2017/0667/P 121 - Kentish Town Road

Application form

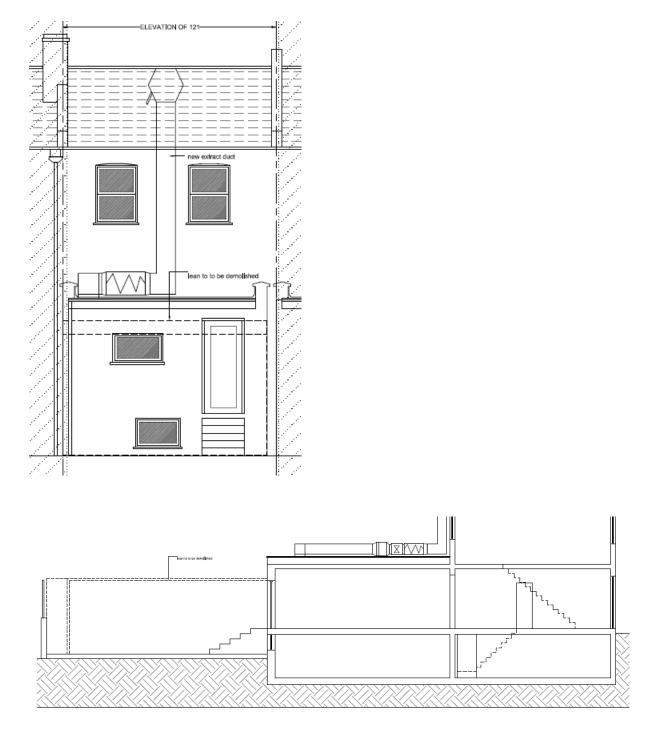
The existing frontage does not conform with the application drawings, as it has no ransom light in the central pane. It does not accord with Camden's guidance as it has no stall-riser / opaque lower panel. Compare the facades of shops nearby.

The frame should not be of painted metal but of timber in recognition of the building's history. A new, more appropriate design is required
